Access Compliance Report

Public Rights-of-Way

(Curb Ramps)

Intersection ID: 30314	Main Street: ROCKET_LN	Cross Street: SHINKANSEN_DR	Location: N
ADA ID: 5A6E2A403ED5	Ramp Type: BlendTrans1	Initial Pass/Fail: Fail	Overall Compliance: No
Severity Score: 10			
Codes/Mitigation Info/Possible Solution		Field Measurements/Component Compliance

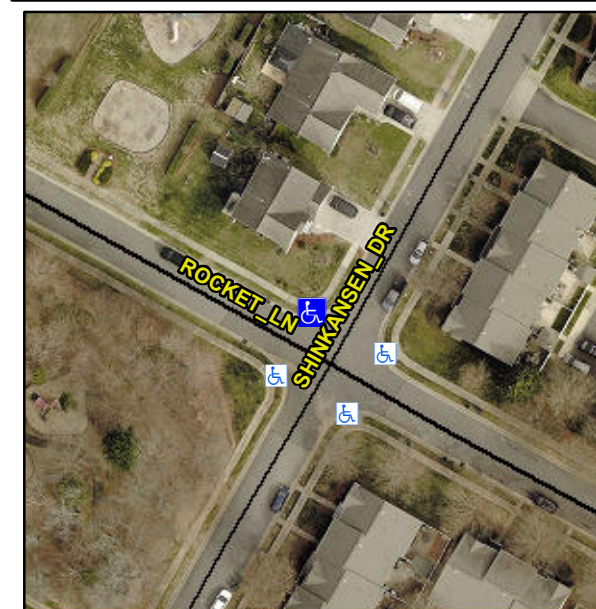
Not Found, R304.5.1, R304.5.3

Compliance	Description	Data	Compliance	Description	Data
N/A	Ramp Length (in)	48.0	Yes	BlendTrans Slope (%)	3.9
No	Ramp Width (in)	41.5	No	BlendTrans XSlope (%)	4.2
N/A	Flare Type LT	N/A	N/A	Flare Type RT	N/A
N/A	Flare Slope LT (%)	N/A	N/A	Flare Slope RT (%)	N/A
N/A	Flare Traversable LT?	N/A	N/A	Flare Traversable RT?	N/A
N/A	Landing Length (in)	N/A	N/A	DWS Provided?	N/A
N/A	Landing Width (in)	N/A	N/A	DWS Contrast?	N/A
N/A	Landing Slope (%)	N/A	N/A	DWS Length (in)	N/A
N/A	Landing X Slope (%)	N/A	N/A	DWS Full Width?	N/A
N/A	Landing Curb? (Y/N)	N/A	N/A	DWS Offset (in)	N/A
N/A	Shared Landing?	N/A			
N/A	Gutter Ponding?	N/A	N/A	Gutter Slope (%)	N/A
N/A	Gutter Lip Ht (in)	1.0	N/A	Gutter X Slope (%)	N/A
N/A	Painted X Walk1?	No	N/A	Painted X Walk2?	No
	X Walk 1 Direction	To SW		X Walk 2 Direction	To SE
	X Walk 1 Width (in)	N/A		X Walk 2 Width (in)	N/A
	X Walk 1 Slope (%)	4.4		X Walk 2 Slope (%)	4.1
	X Walk 1 X Slope (%)	6.7		X Walk 2 X Slope (%)	2.2

N/A	Ramp inside XWalk1?	N/A	N/A	Ramp inside XWalk2?	N/A
	Road Slope (%)	3.4		Clear Space?	N/A
	Road X Slope (%)	4.0	N/A	Clear Space to XWalk (in)	N/A
N/A	Any Obstructions?	N/A	N/A	Storm Grate/Utility Hazard?	N/A
	Obstruction Type			Storm Grate/Utility Type	
		N/A			N/A
			Yes	Surface Condition? (G/P)	Good
			No	Curb Slope (%)	19.2

Remove & Replace Curb Ramp With Two New Directional Ramps or Equivalent.
